August 27, 2015  
SBK-L-15138  
Docket No. 50-443

Seabrook Station

NextEra Energy Seabrook, LLC's Fifth Six-Month Status Report in Response to March 12, 2012  
Commission Order Modifying Licenses with Regard to Reliable Spent Fuel Pool Instrumentation  
(Order Number EA-12-051)

## SPENT FUEL POOL LEVEL SENSOR LOCATION DIAGRAM

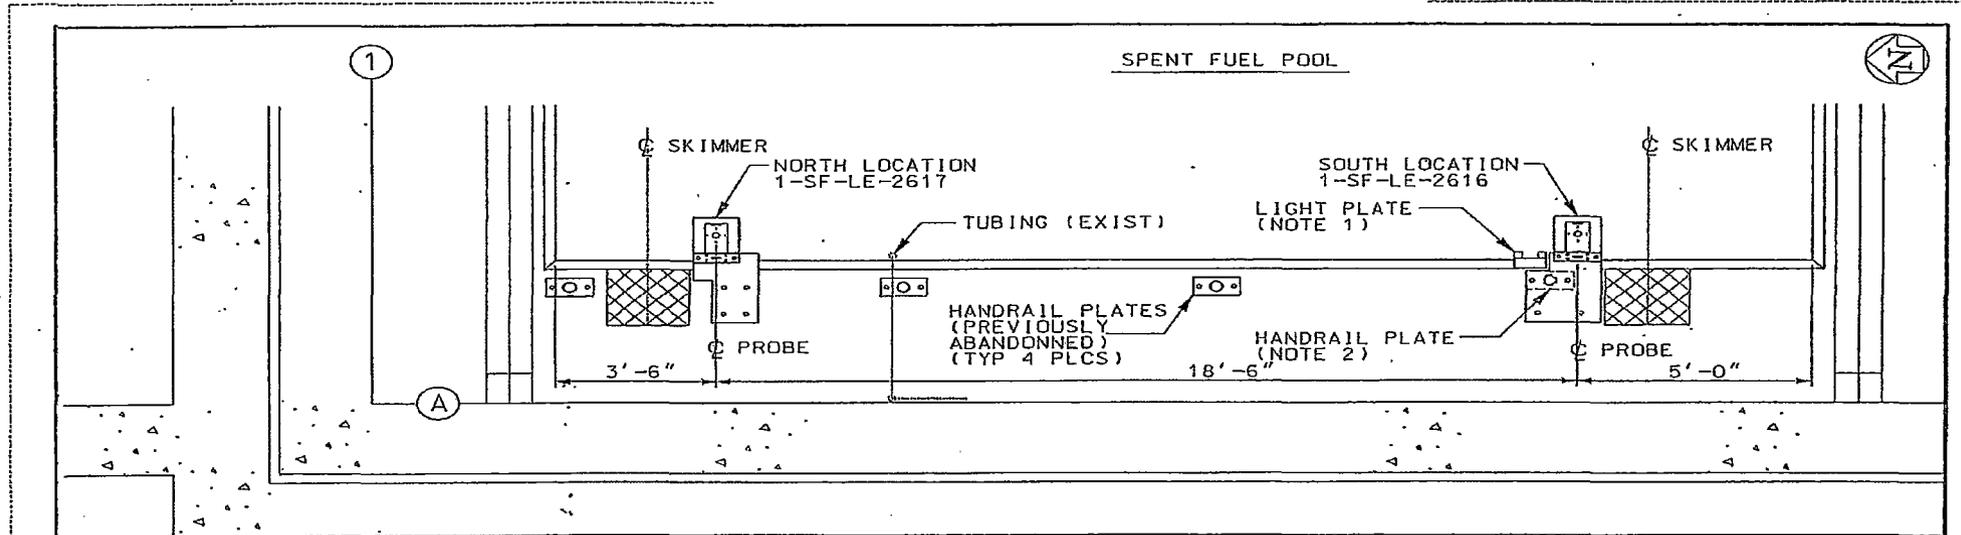
Question No.	NRC QUESTION	LICENSEE RESPONSE
		<p><i>The Overall Integrated Plan for Seabrook Station stated that the primary and backup instrument channel sensors for monitoring Spent Fuel Pool level would be located in the northwest and southwest corners of the Spent Fuel Pool (SFP) with the signal cable routed in rigid steel conduit to the adjacent west wall of the Fuel Storage Building (FSB). The plan also noted that the corners of the SFP would provide inherent missile protection for the level sensor probes in the pool.</i></p> <p><i>Subsequently, a detailed review of the plan has identified several implementation concerns. Installation of the sensor mounting brackets would require removal of 1/2 inch steel plates that were installed during plant construction to form the non-pool side of the curb that supports the stainless SFP liner (Ref. Attachment B). These plates are recessed into the Fuel Handling Machine (FHM) rail pockets. Removal of the plates will be very difficult and the process of removing the plates presents risk for potential damage to the SFP curb. Removal of the plates also presents potential FME and personnel safety concerns due the limited work space next to the pool. The final design will also result in limited clearance (~1-1/2 inch) between the sensor mounting brackets and the frame of the FHM. Considering these concerns, alternative locations for SFP level sensor mounting are being considered and evaluated.</i></p> <p><i>Evaluation of the alternate mounting locations considered FHM clearance, potential impact of bracket mounting on the attachment structure, access and maintainability of the level sensors and the impact that the location would have on normal SFP operations and support activities. The review also considered the potential for adjacent equipment and structure over the SFP to impact functionality of the sensors during a Beyond Design Basis External Event (BDBEE).</i></p> <p><i>The evaluation considered alternate mounting locations on the east and west sides of the SFP. The north and south sides of the SFP were not considered to be viable locations for sensor mounting since the FHM traverses the entire length of the SFP which presents the clearance and curb concerns noted above. The east side of the SFP contains the fuel transfer gate, two fuel pool lighting fixtures, two embedded SFP purification system skimmer intakes, 10 inch SFP cooling system discharge piping and 4 inch SFP filter system return piping, and a permanent storage location for one of the fuel handling tools. This side of the SFP is also used as the personnel access point and work area for SFP operations including: spotting during fuel movements, inspection camera access, Operator access for transfer gate manipulation and inspections, transfer canal inspections, and temporary storage location for radioactive wastes prior to survey and removal by Health Physics personnel. The west side of the SFP contains two SFP purification system skimmer intakes, three fuel pool lighting fixtures and the sensor for the existing SFP level instrumentation (1-SF-LE-2607). This side of the SFP is also used as the personnel access point for maintenance of the existing pool level instrumentation and cleaning of two of the skimmer intake basket filters.</i></p> <p><i>Based on current activities for SFP operations, and considering the physical limitations for mounting the sensor bracket and sensor signal cable access, the west side of the SFP is considered to be the preferred mounting location for both the primary and backup instrument channel sensors. However, due to the interferences described above (FHM rails on the north and south walls, the various appurtenances, equipment and access on the east wall and the skimmers inboard of the FHM rails on the west wall) sensor mounting will be on the west wall, physically separated by approximately 18 feet (min.) on center as shown in Enclosure 3.</i></p>

1. THE EXISTING UNDERWATER LIGHT ASSEMBLY BRACKET, WELDED TO THE SFP CURB ANGLE PER EC14371 AND LOCATED ADJACENT TO 1-SF-LE-2616, IS TO BE ABANDONNED IN PLACE AND A NEW BRACKET WILL BE INSTALLED BY EC281537. A MINIMUM OF 3'-0" NORTH OF THE PROBE CENTERLINE. REFERENCE SK 111576-EC281849 SHEET 2. SEE EC281537 FOR DETAILS SPECIFIC TO THE RELOCATION OF THE LIGHT ASSEMBLY.
2. EXISTING HANDRAIL ANCHOR PLATE TO BE REMOVED. HILTI'S ARE TO BE LEFT IN PLACE AND REUSED FOR NEW INSTRUMENT PLATE.

Pool Side Bracket Design and Seismic Requirements

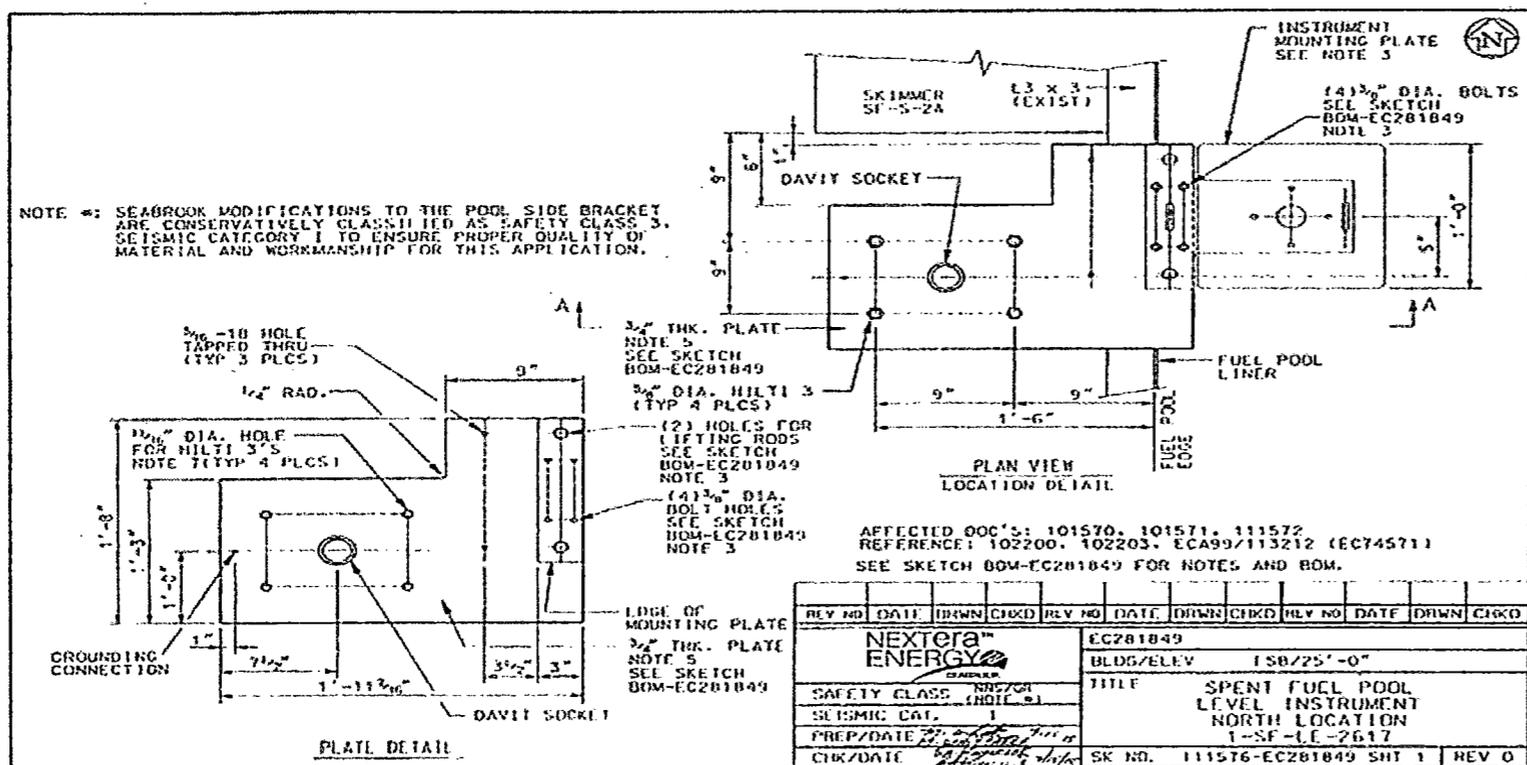
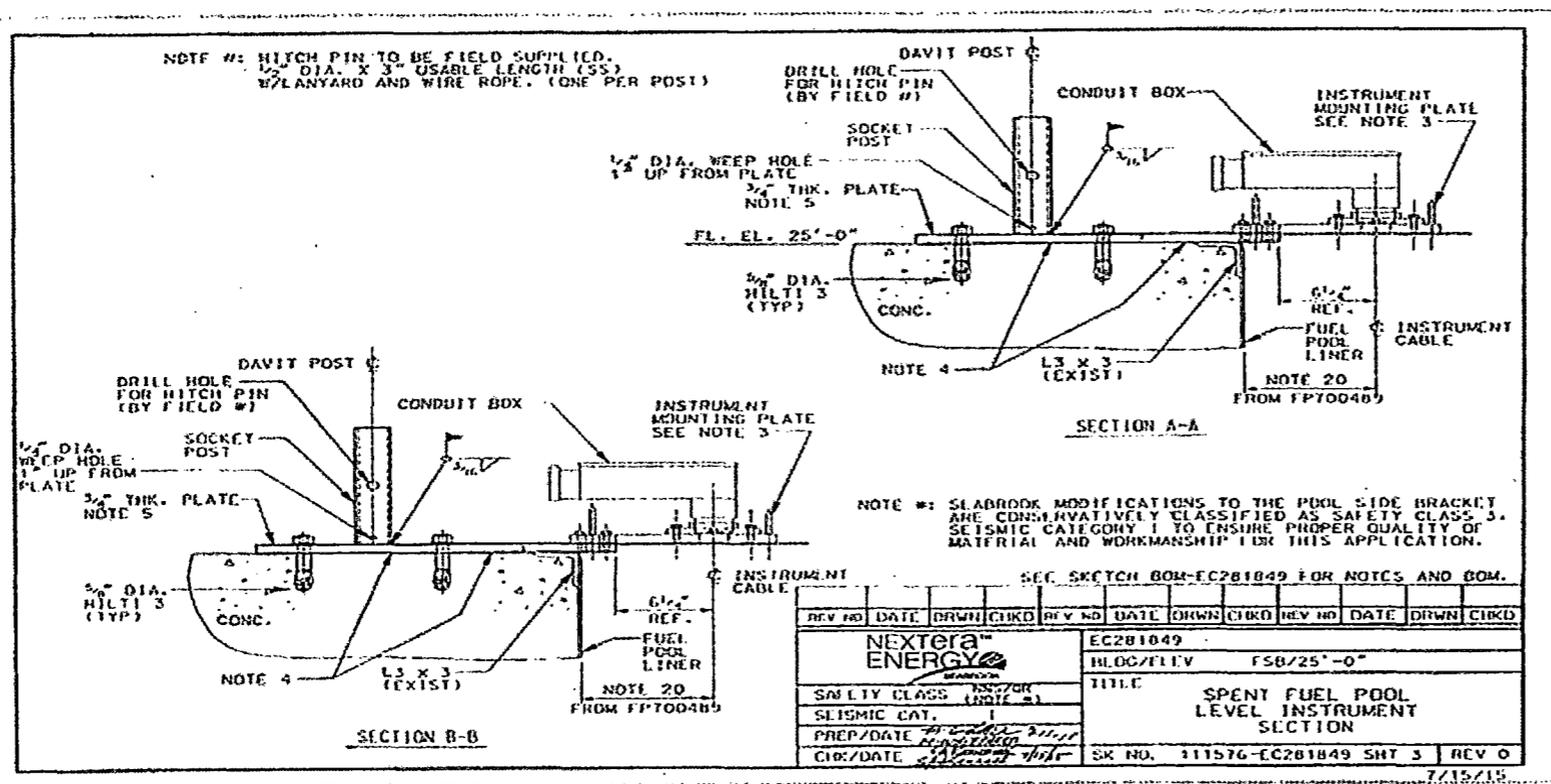
3. Revised the pool side bracket design to support relocation as described above.
4. Revised responses to address requests for addition information during the 2015 NRC FLEX Audit.

Question No.	NRC QUESTION	LICENSEE RESPONSE
		<p>The bracket assembly that supports the sensor probe and launch plate will be mechanically connected to the SFP structure. The mechanical connection consists of four concrete expansion anchors that will bolt the bracket assembly to the SFP structure via the base plate. The loads for the bracket concrete anchors were established by Seabrook based on translation of loads established by Westinghouse for the Pool-side bracket in Seismic Analysis CN-PEUS-14-16 (Reference 14). The concrete expansion anchors will be designed by Seabrook to meet the calculated Westinghouse loads (tension and shear loads) for the Seabrook modified bracket design with appropriated safety margin.</p> <p>Seabrook design change EC 281849 modified the Westinghouse sensor probe 'Z'-shaped, stainless steel, probe bracket to allow for installation along the West side of the SFP (Ref. Enclosure 4). Each of the modified probe mounting plate will bolted to the West pool side concrete using four 5/8" diameter Hilti III stainless steel anchors each having a 4" minimum concrete embedment. Eccentric loads on the cantilever plate bolt group are checked based on forces and moments at the center of the Hilti Plate/cantilever plate taken from page 27 of the Westinghouse analysis (Reference 14).</p> <p><u>Loads at Center of HKB3 Group</u>  <math>F_x = 65\#, F_y = 279\#, F_z = 45\#, M_x = 5,000 \text{ in } \#, M_y = 1,860 \text{ in } \#, M_z = 4,200 \text{ in } \#</math>  <u>SS HKB III Allowables</u>  <math>Tension = 2,065\#, Shear = 4,160\#</math></p> <p><u>Interaction</u>  <math>IR \text{ bolt} = T_{\text{bolt}} / T_{\text{allowable}} + V_{\text{bolt}} / V_{\text{allowable}} = 0.465 &lt; 1.0 \dots OK</math></p> <p>The HKB III bolts control the connection design which is based on conservative and maximum bolt tension and shear taken from the Westinghouse Strudl model. Base plate bending and shear stresses will be small due to minimal loading on the 3/4" cantilever plate.</p>
